HISTORIC AND DESIGN REVIEW COMMISSION

HDRC CASE NO: 2025-093
COMMON NAME: 508 & 510 BOOKER ALLEY
LEGAL DESCRIPTION: NCB 560 BLK 18 LOT W 21.2 FT OF E 30 FT OF N 86.62 FT OF 9
NCB 560 BLK 18 LOT E 8.8 OF N 86.62 OF 9 & W 29.7 OF N 86.62 FT
OF 9
ZONING: R-4, H
CITY COUNCIL DIST.: 2
DISTRICT: Dignowity Hill Historic District
APPLICANT: Felix Ziga/Ziga Architecture Studio, PLLC
OWNER: RAMIRO MORENO/RAMIRO MORENO
TYPE OF WORK: Construction of a 2.5-story, single family residential structure and a
detached, 2-story accessory structure
APPLICATION RECEIVED: April 10, 2025
60-DAY REVIEW: June 9, 2025
CASE MANAGER: Edward Hall
REQUEST:

1. Construct a 2.5-story, single-family residential structure on the lot identified as 510 Booker Alley.
2. Construct a 2-story, residential structure on the lot identified as 508 Booker Alley. The structure has been positioned as an accessory structure to the structure proposed at 510 Booker Alley.

2 PROPOSED SITE/ROOF PLAN

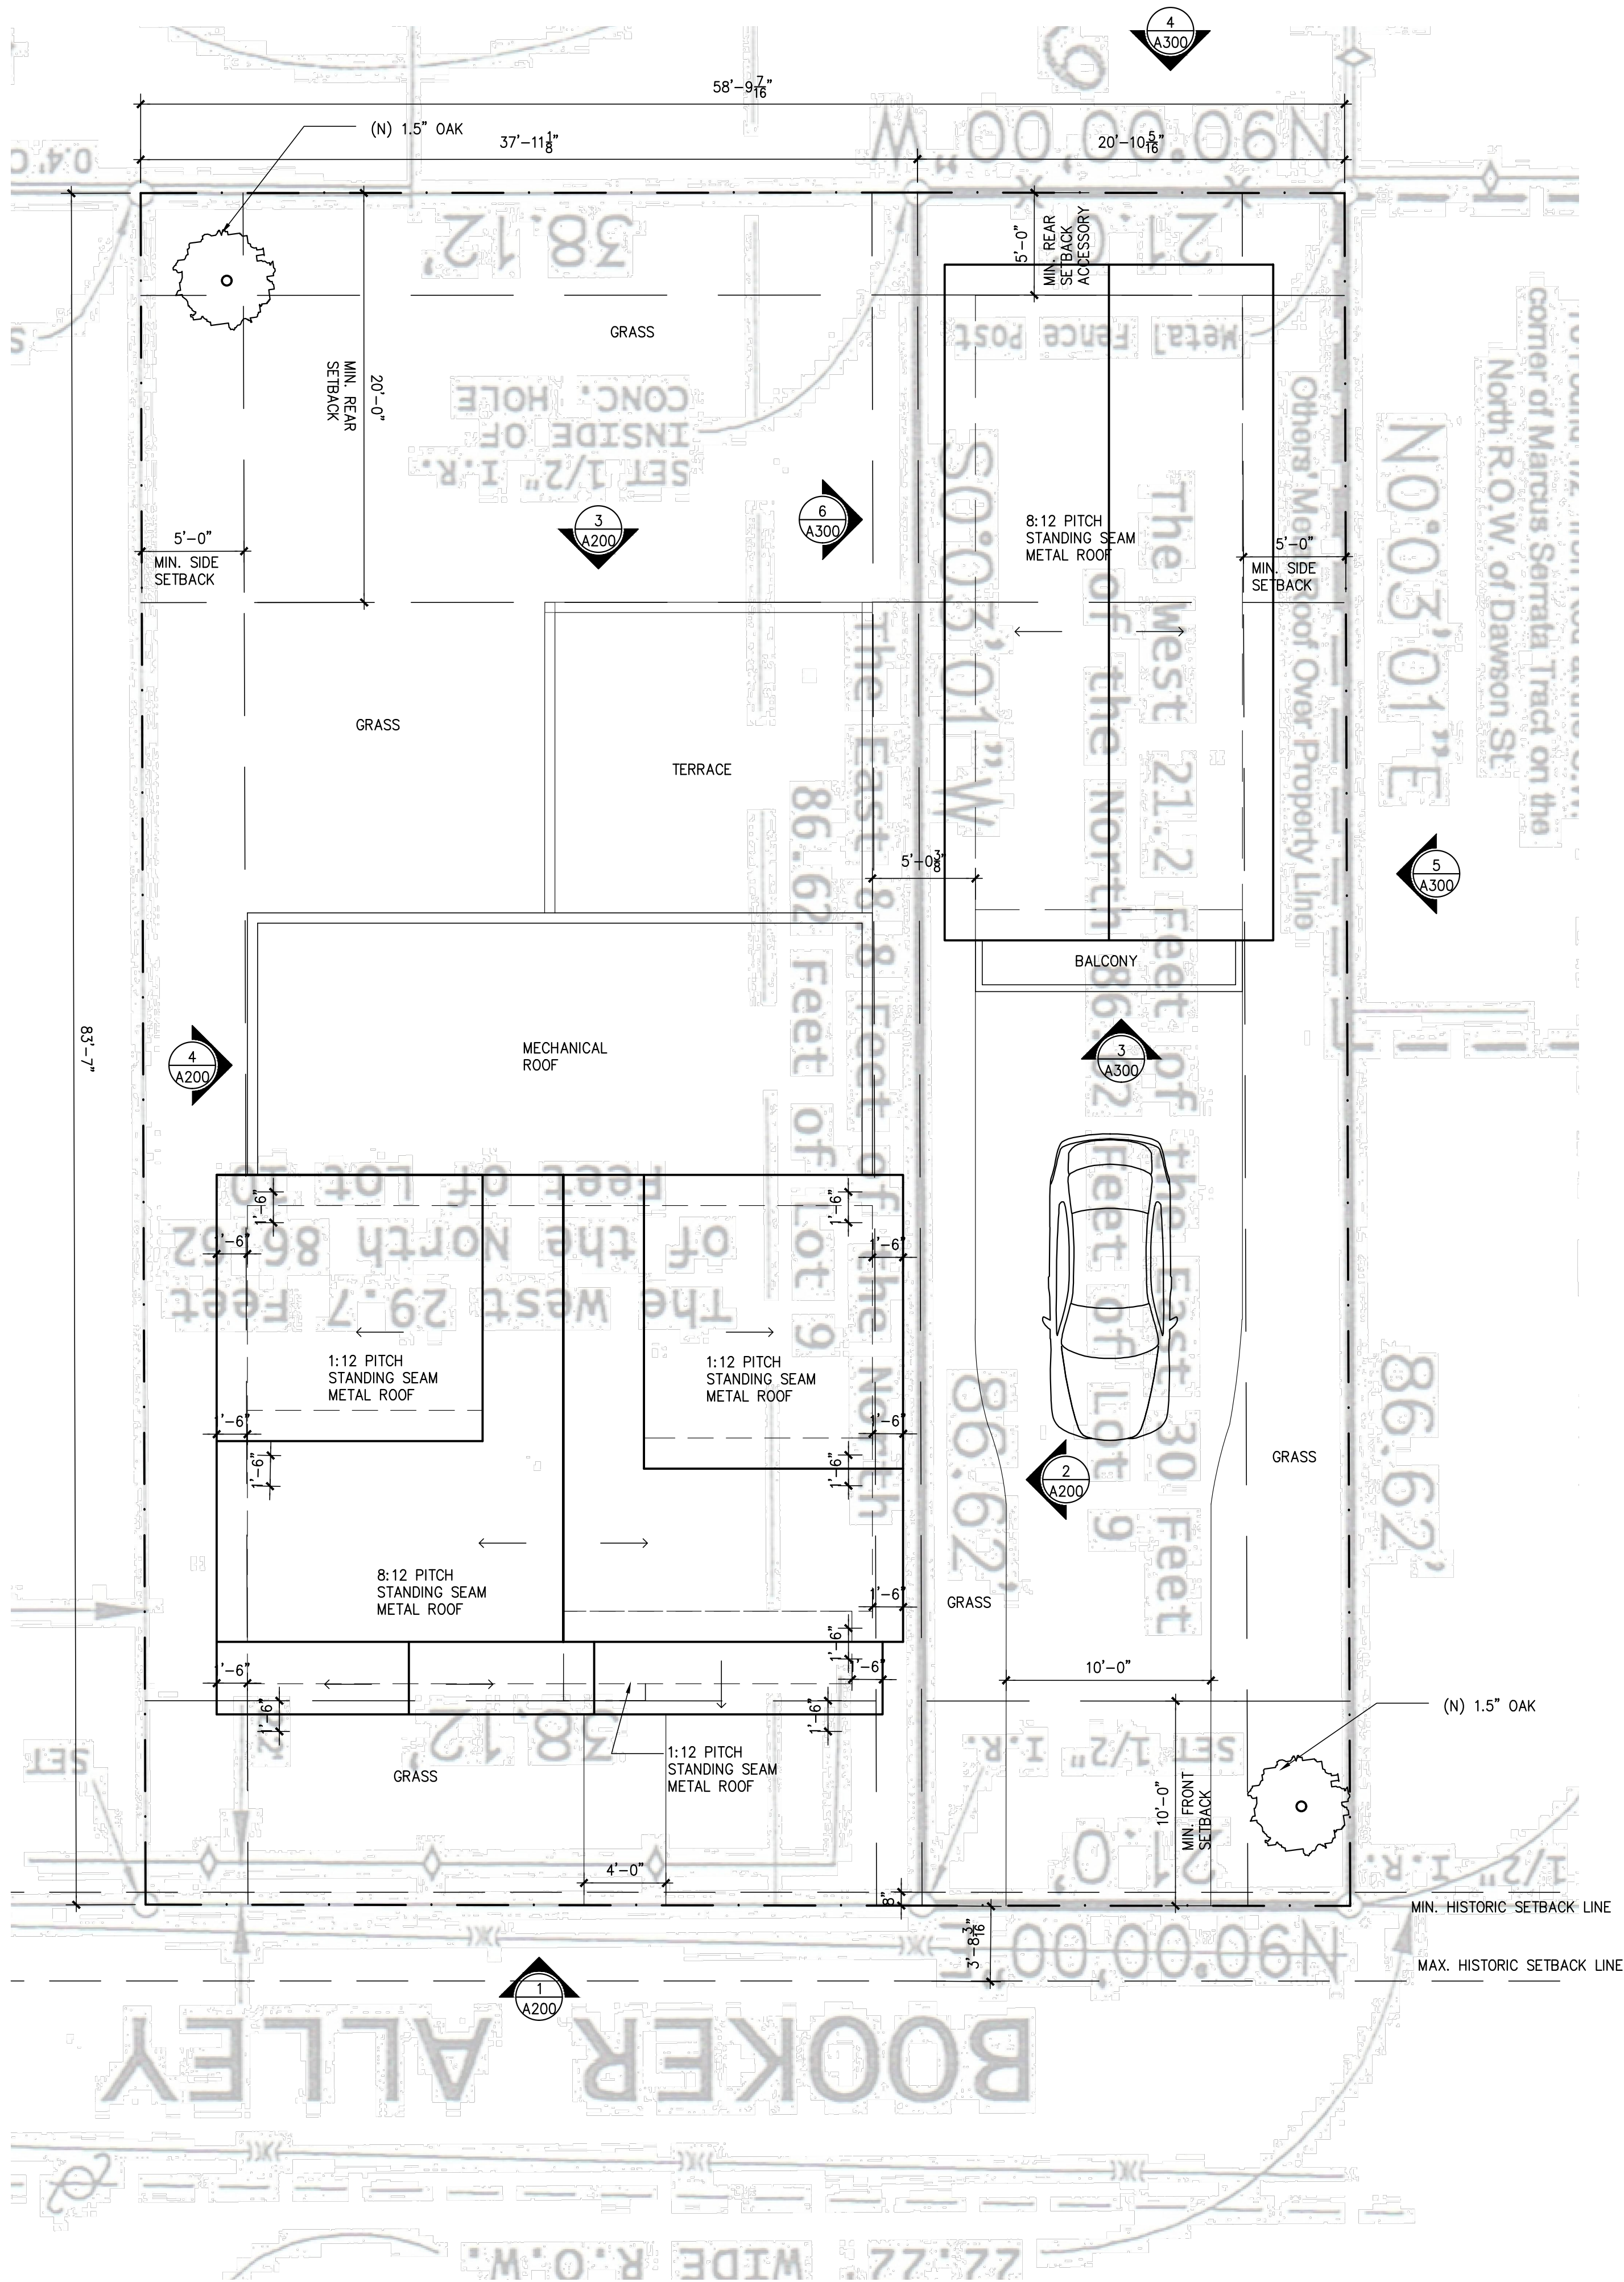
The proposed building footprints have been adjusted to fit within the allowed 50% lot area. Calculations have been added to sheet SP100.

- xii. That a detailed landscaping plan be developed and submitted for review and approval. Landscaping should be developed in a manner that is consistent with the Guidelines for Site Elements. ***Please let me know if you'd like an example of an appropriate landscaping plan.***

Landscaping information was added to sheet SP100.

LOT SIZE: 4,917 SF
BUILDING FOOTPRINT: 1,802 SF
1802/4917 = .36 = 36% LOT COVERAGE
